Work Order ID 84886

Item Name: Skidtube LH

DART SERVICE INSTRUCTION

TO AMEND INSTALLATION INSTRUCTIONS IIN-D209-669 REV. B

INSTALL TOW RING ASSEMBLY AS SHOWN BELOW (REFER TO SECTION F-F OF IIN-D209-669 REV. B.

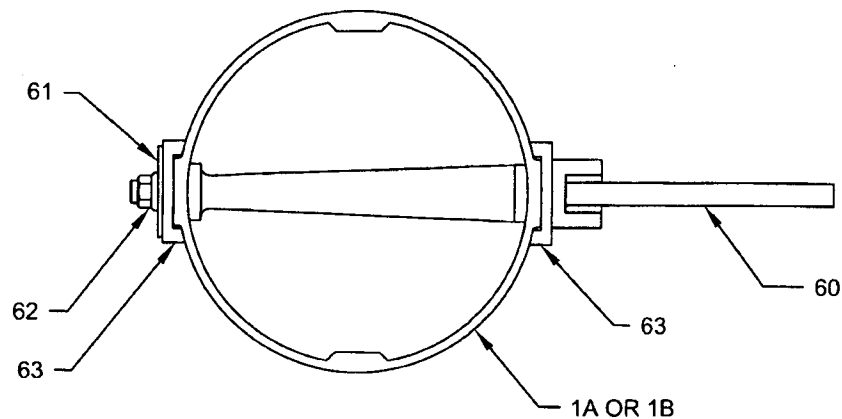
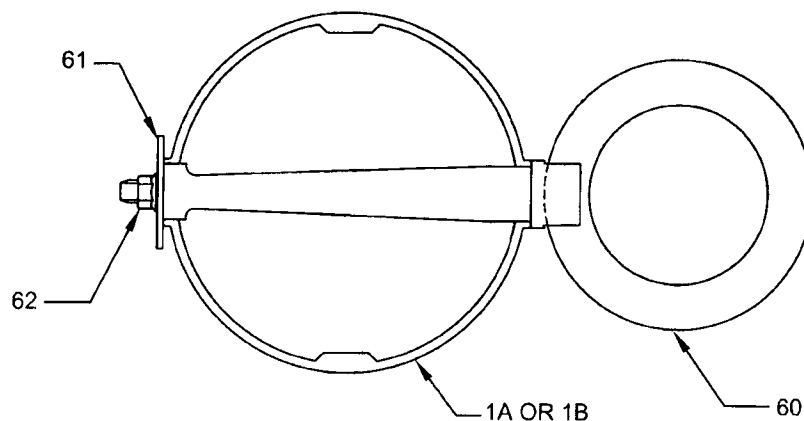
IS:

WAS:

- 1) FOR D209-669-011/-012/-013/-014 SKID TUBES @ CHANGE 003 AND SUBSEQUENT, MODIFY THE FOLLOWING:
 - a) REPLACE THE D2968-041 TOW RING WITH THE D3407-041 TOW RING ASSEMBLY.
 - b) REPLACE THE D2736-1 AND D2736-3 GHW LUGS WITH THE D3405-041 AND D3405-043 LUG ASSEMBLIES.
 - c) AMEND THE PARTS LIST IN SECTION 5.0 OF INSTALLATION INSTRUCTIONS IIN-D209-669 REV. B AS SHOWN ON PAGE 2 OF THIS DSI.
